CITY OF DOVER

PLANNING TECHNICAL REVIEW COMMITTEE –AGENDA

PLAN SNAPSHOT REPORT SITE-2023-0011 FOR CITY OF DOVER, N.H.

Plan Type: Site Plan - Major
Work Class: New Construction
Status: In Review
Valuation: \$0.00
Description: Proposed 3,300 sq ft - Bank with Drive-Up ATM

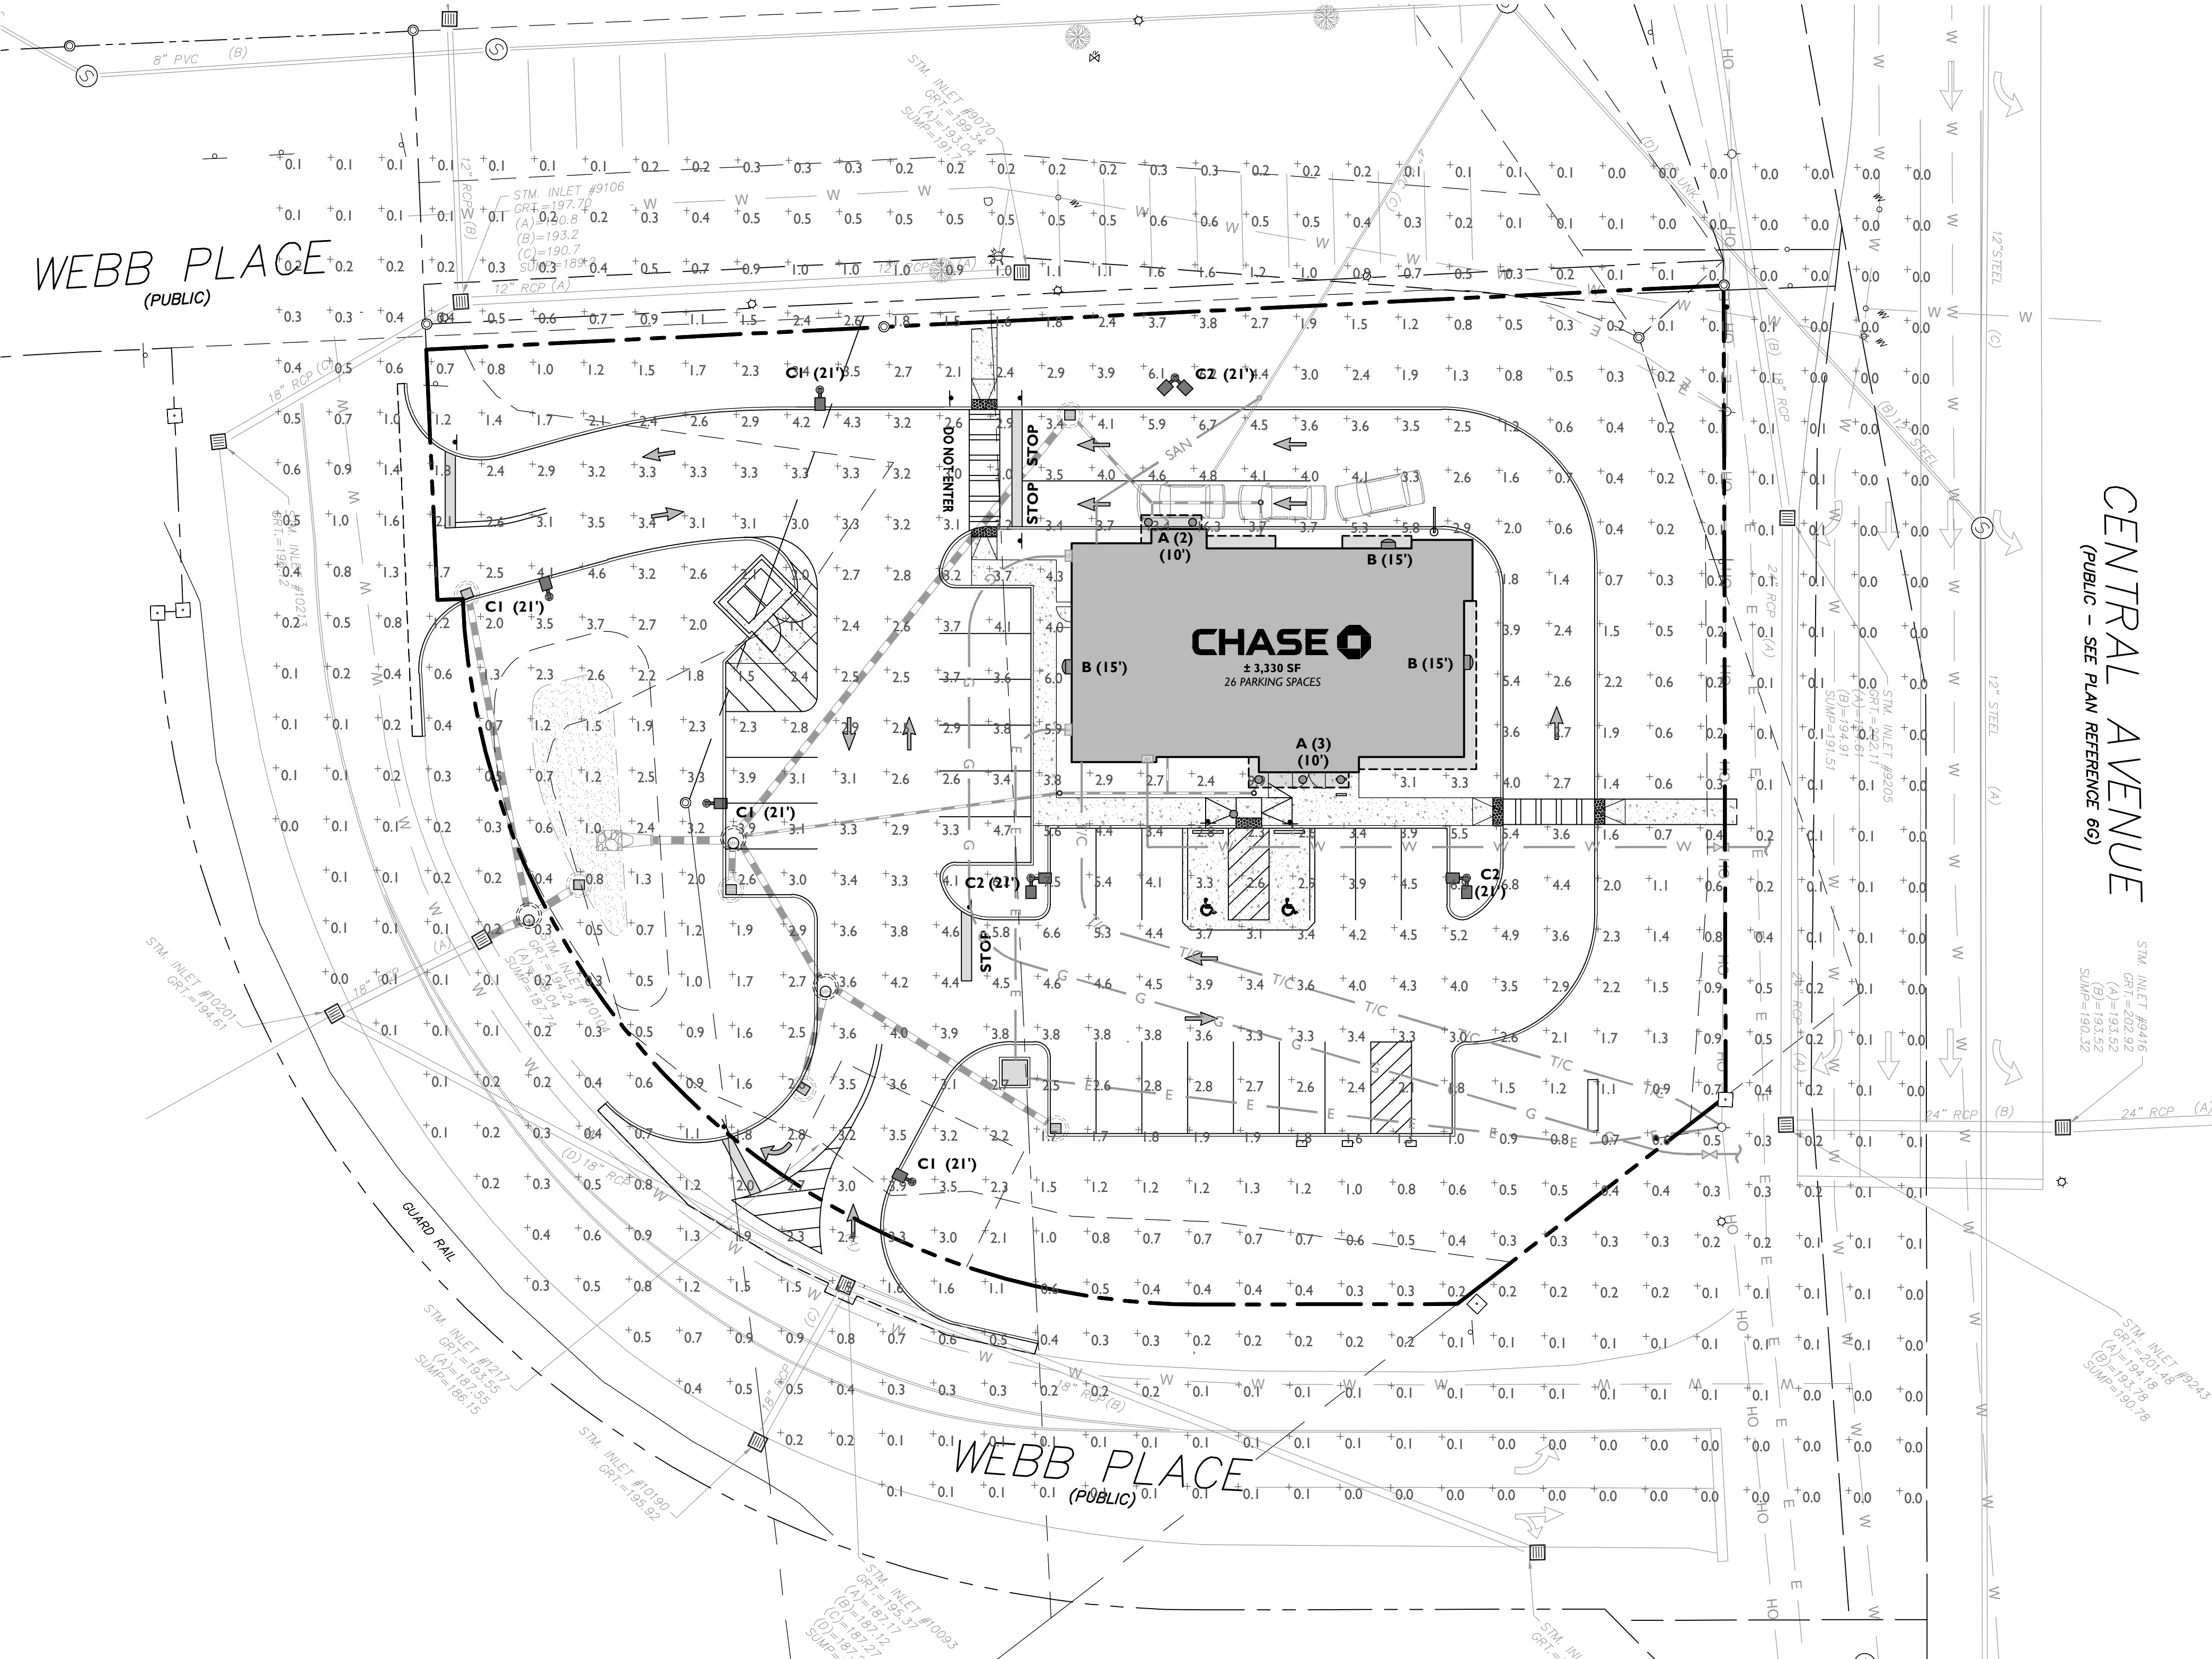
- o 4-inch sewer should have a minimum 2% slope for sewer not 1.08% as noted on the plan.
- Sheet C-7:
- o Lighting is spilling across the property lines. Please provide light shields.

PRE-CAST MANHOLE AND CATCH BASIN DETAIL

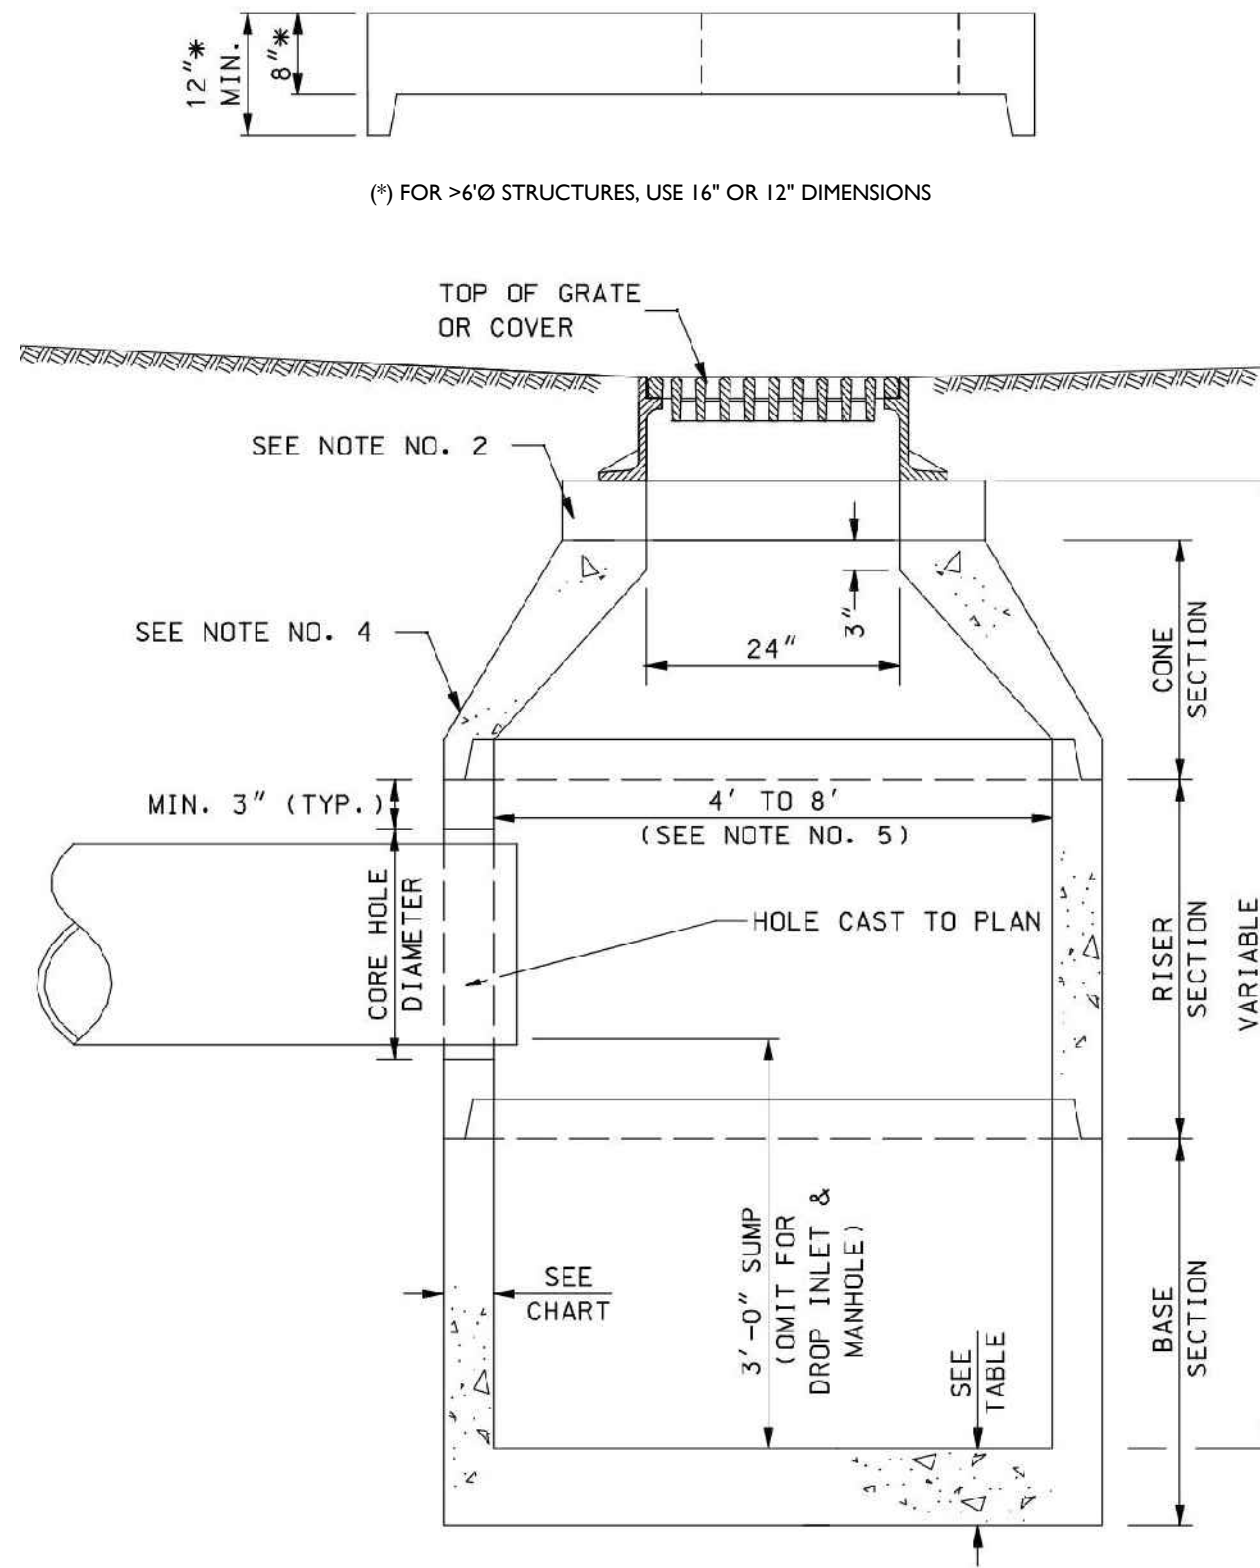
- o Drain Manhole should have 30 inch clear opening. Catch basins may have 24 inch diameter opening.
- o Storm basin detail should show ESHWT to ensure it complies with NHDES recommendations.

CONSTRUCTION SIGN DETAIL

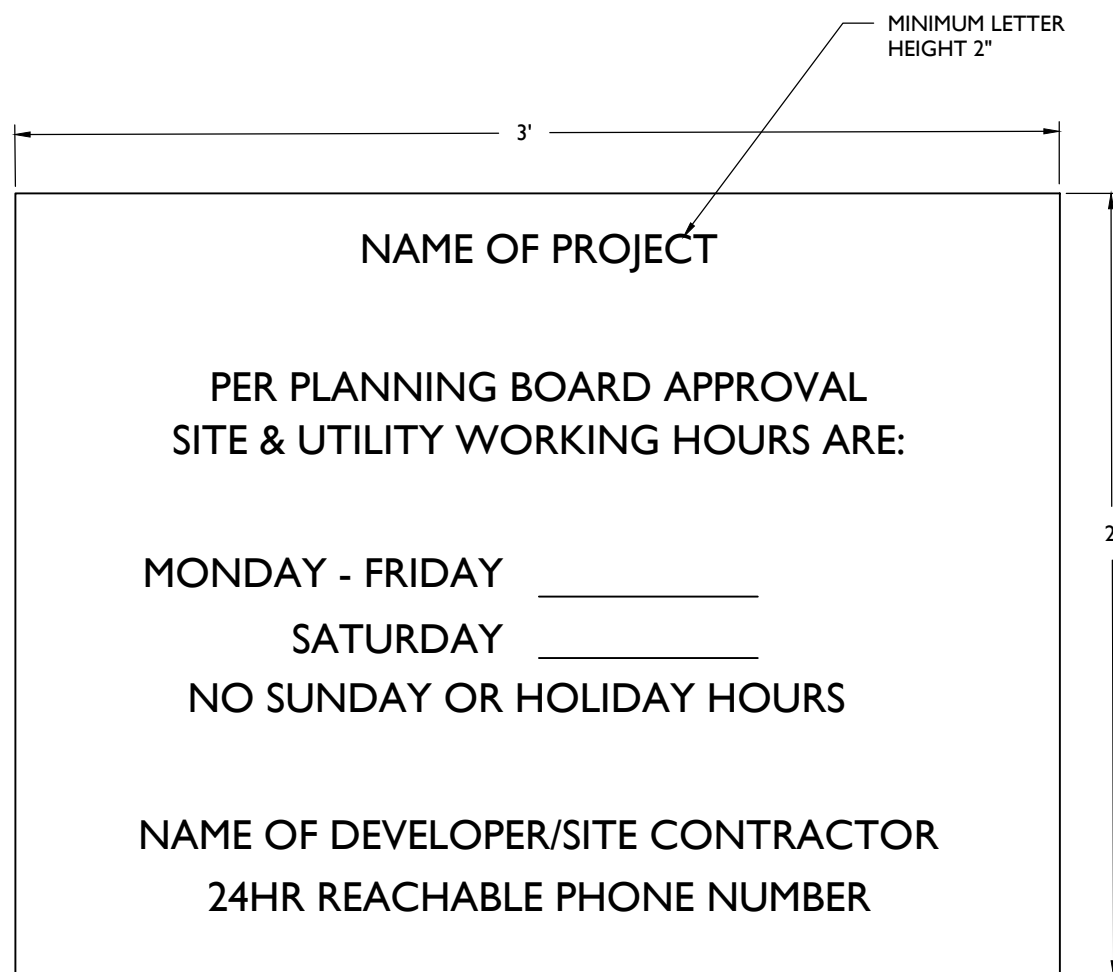
o Provide detail for Construction Sign that conforms to the City of Dover standard details and as noted in the Dover standard notes.
